STATE OF NORTH CAROLINA
DEPARTMENT OF TRANSPORTATION

Subject: **Application for Modification to Section 404 Nationwide Permits 23 and 13, Section 401 Water Quality Certification, and Neuse Riparian Buffer Authorization** for the replacement of Bridge No. 143 over Beaverdam Creek on SR 2217 (Old Milburnie Road), Wake County. Federal Aid Project Number BRZ-2217(1), WBS No. 33641.1.1, State Project No. 8.2409501, Division 5, T.I.P No. B-4304.

The purpose of this submittal is to request a modification to the Section 404 permit, Section 401 Water Quality Certification, and Neuse Riparian Buffer Authorization for B-4304. Please see the enclosed copies of the revised permit drawing sheets 6 and 7 of 9, revised Neuse Buffer impact drawing sheet 7 of 7, and revised summary tables for the above-referenced project.

STREAM & WETLAND IMPACTS

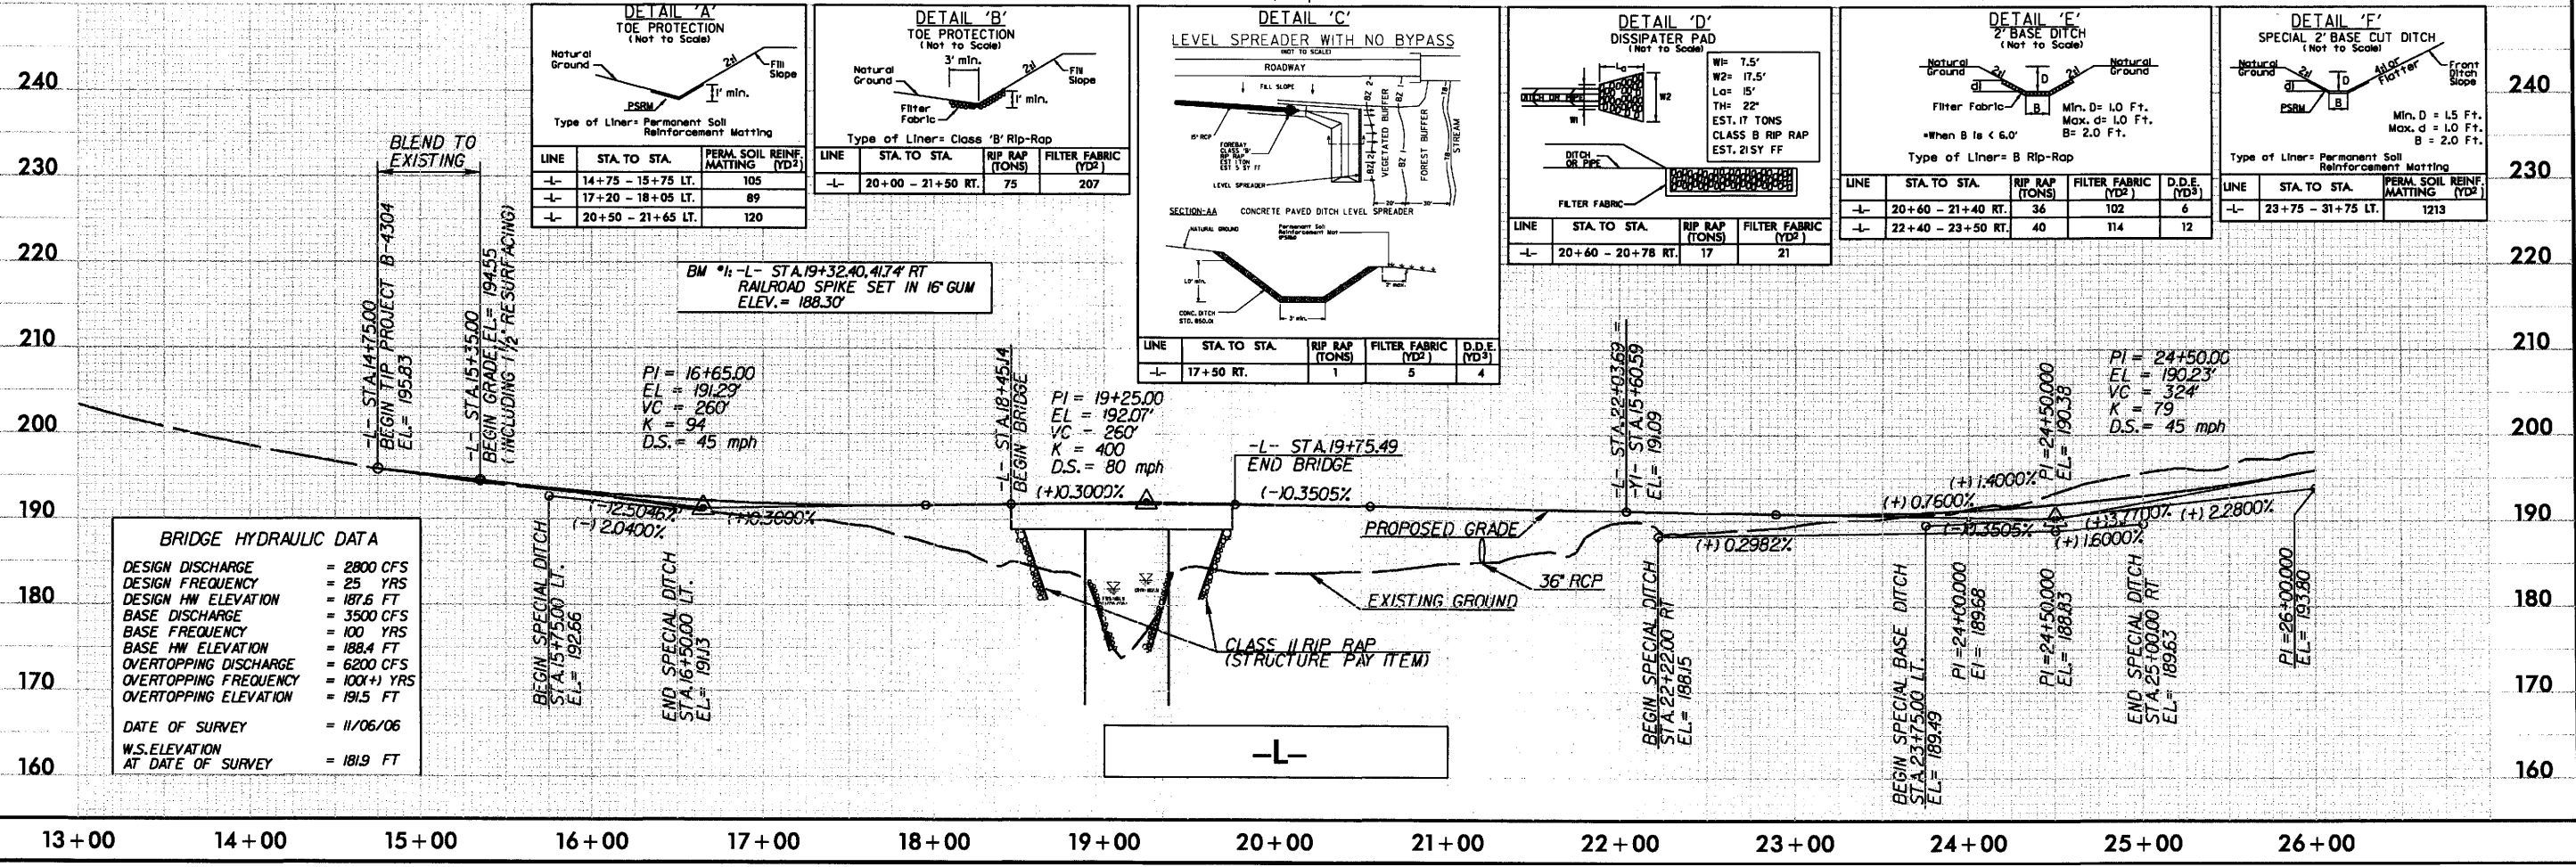
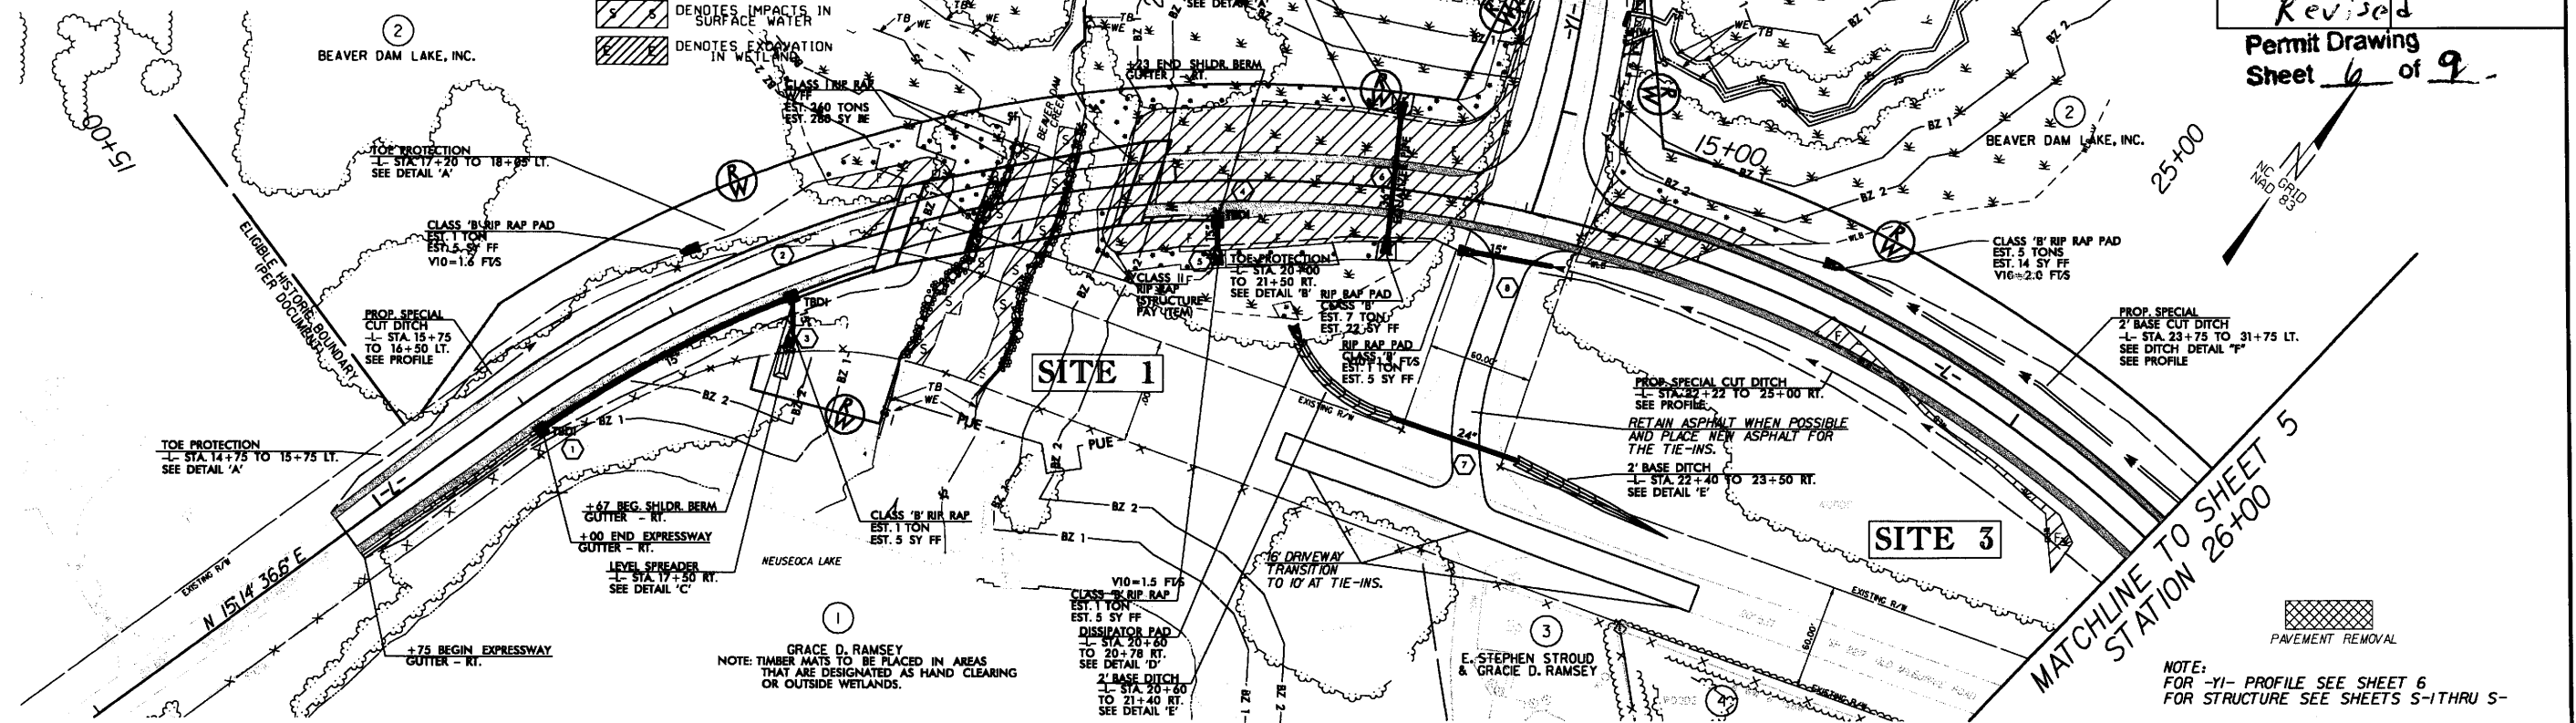
Permit drawings have been revised to depict rip rap on natural ground at inlet and outlet of the equalizer pipe. Installation of the rip rap will require excavation in wetland. Accordingly, these impacts on Stream/Wetland Permit Drawings have been revised from mechanized clearing in wetland to excavation in wetland at the rip rap. The original permit drawings (Stream/Wetland Permit Drawing Sheets 6 and 7 of 9 and Buffer Permit Drawing Sheet 7 of 7) depict no rip rap at the inlet or outlet of the pipe.

The original permit drawings (Stream/Wetland Permit Drawing Sheets 6 and 7 of 9 and Buffer Permit Drawing Sheet 7 of 7) depict a 36 inch pipe structure that will be collared and extended. A recent recalculation of impacts indicates that an additional 10 linear feet of permanent existing perennial stream impacts may be necessary for bank stabilization activities associated with the pipe extension. The original Stream/Wetland Permit Drawing Sheets 6 and 7 of 9 only indicate a mechanized clearing impact at this pipe structure. Extension and collaring of the pipe structure will instead require excavation in wetland. Permit drawings have been revised to depict wetland excavation (<0.01 acres) in lieu of mechanized clearing at the 36 inch pipe structure.

Permit drawings have been revised to depict a level spreader with a Class B rip rap-lined forebay. The original permit drawings (Stream/Wetland Permit Drawing Sheets 6 and 7 of 9 and Buffer Permit Drawing Sheet 7 of 7) depict a level spreader with no forebay.

The original permit drawings (Stream/Wetland Permit Drawing Sheets 6 and 7 of 9 and Buffer Permit Drawing Sheet 7 of 7) depict the special 2-foot base cut ditch with a liner of permanent soil matting and rock check dams. It was determined that the rock check dams are not required. The Permit drawings have been revised to delete the rock check dams in the special 2-foot base cut ditch.

BUFFER IMPACTS

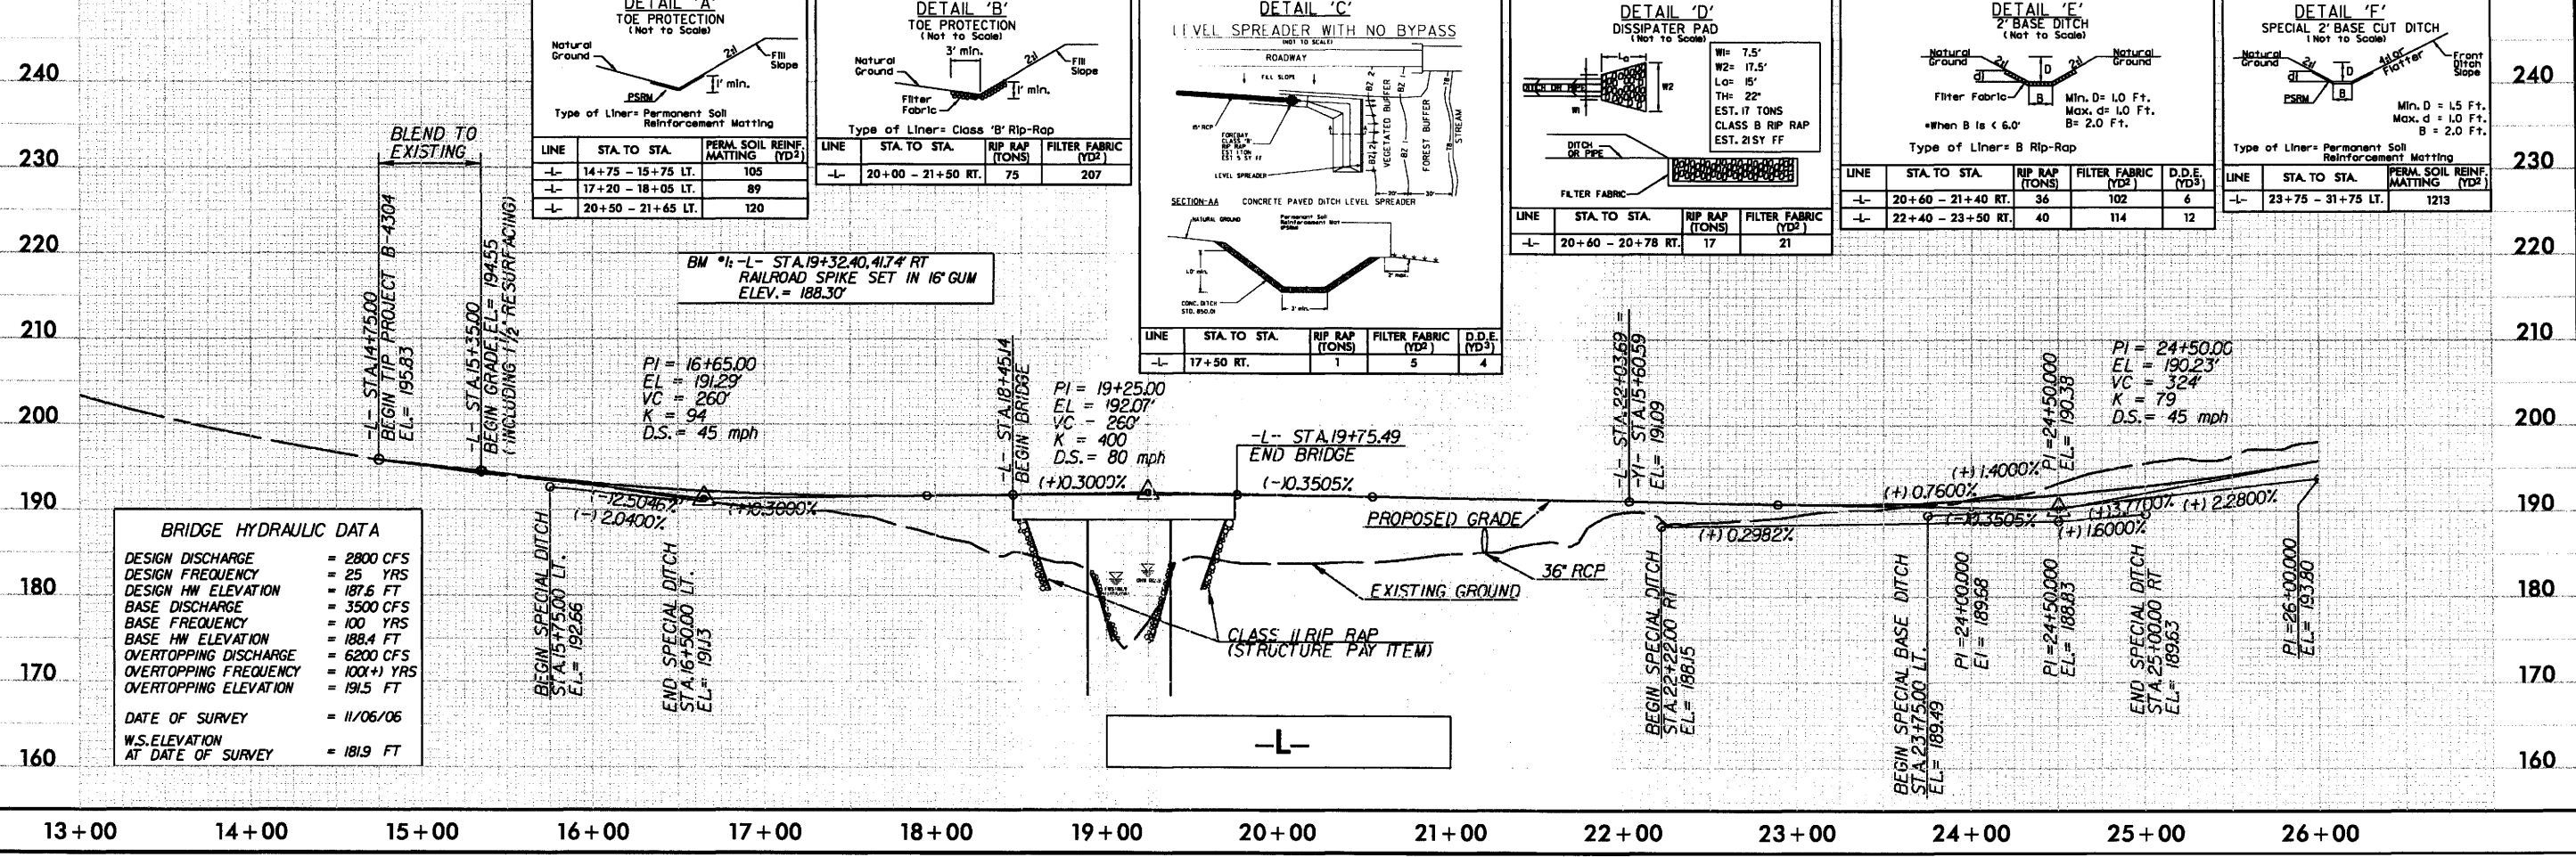
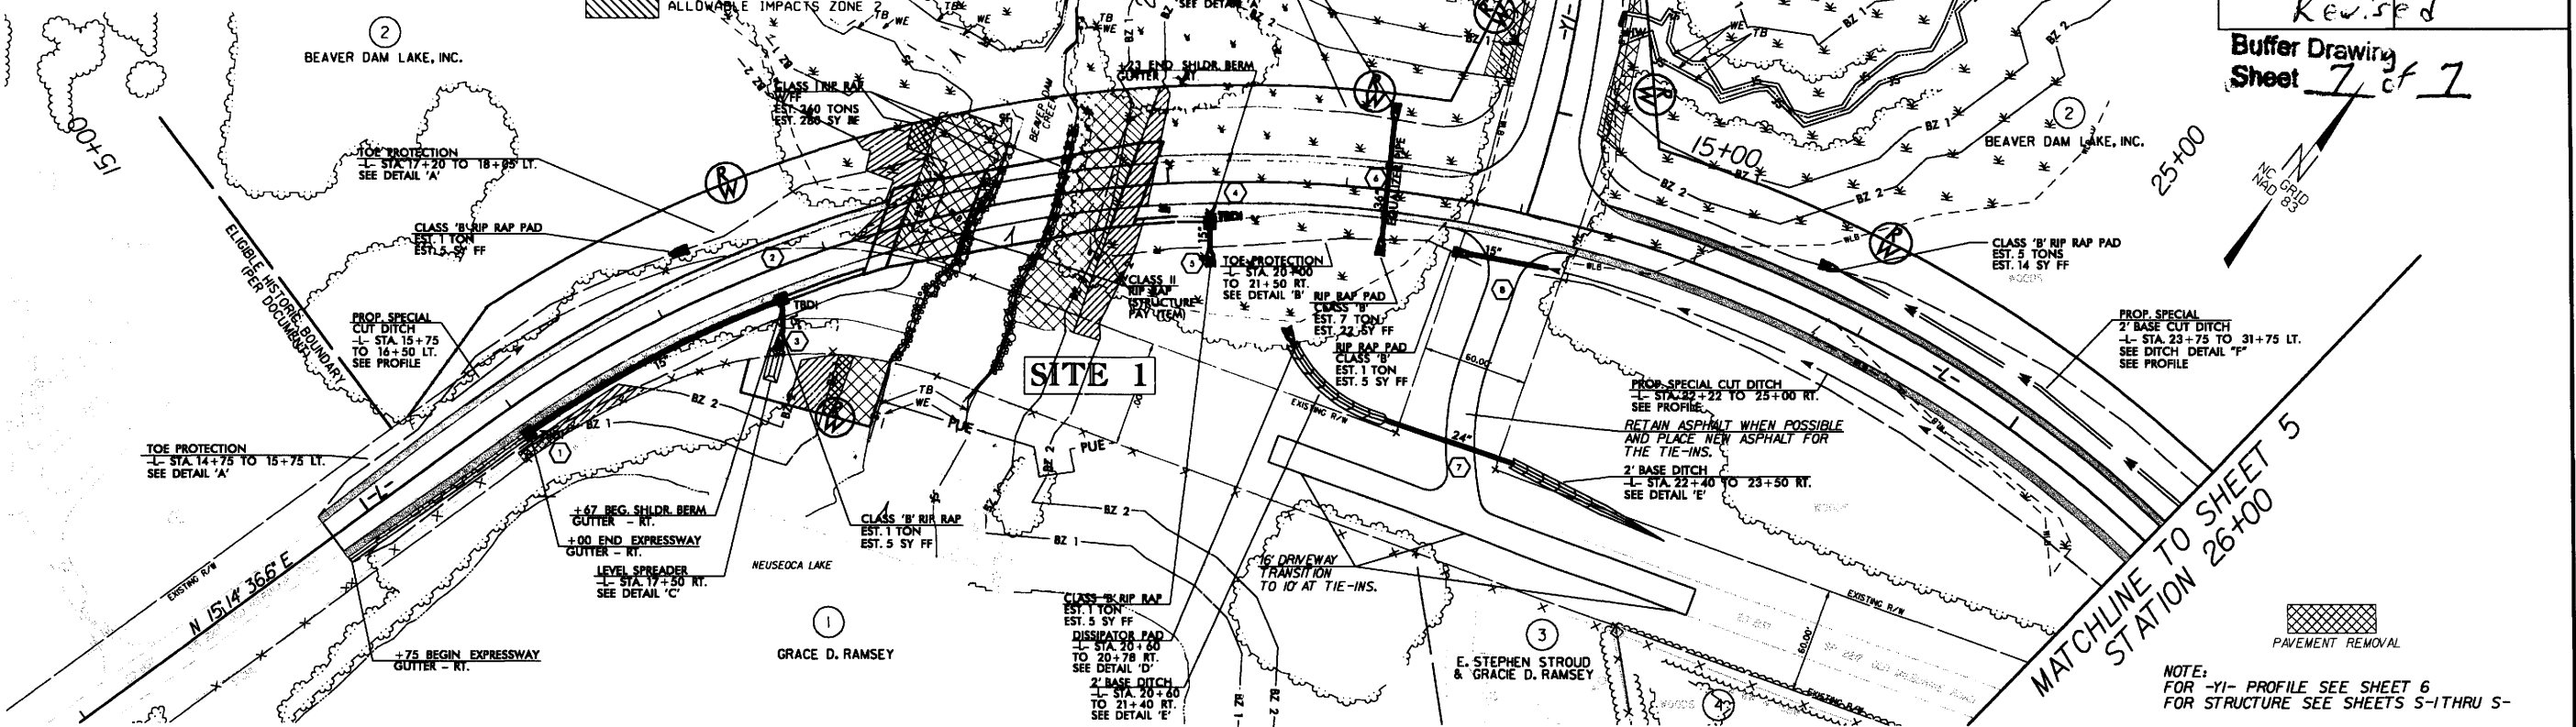
The original Buffer Permit Drawing Sheet 7 of 7 did not accurately depict the footprint necessary to construct the project at this location. The buffer permit drawing has been revised to cover the anticipated construction activities and the outer boundary of buffer impact is now consistent with the outer boundary of wetland impact. This results in an increase in Neuse buffer impact (Road Crossing: Exempt) of 598 square feet in Zone 1 (897 square feet in original permit) and 209 square feet in Zone 2 (604 square feet in original permit) compared to the original permit (Table 1).

The wetland impact in the buffer impact area has increased by 545 square feet in Zone 1 and 210 square feet in Zone 2 compared to the original permit (Revised Wetlands in Buffer Impact Summary Table). No mitigation is required for the increase in buffer impacts because it falls under an exempt activity. No changes in overall mitigatable buffer impacts have occurred since the original permit.
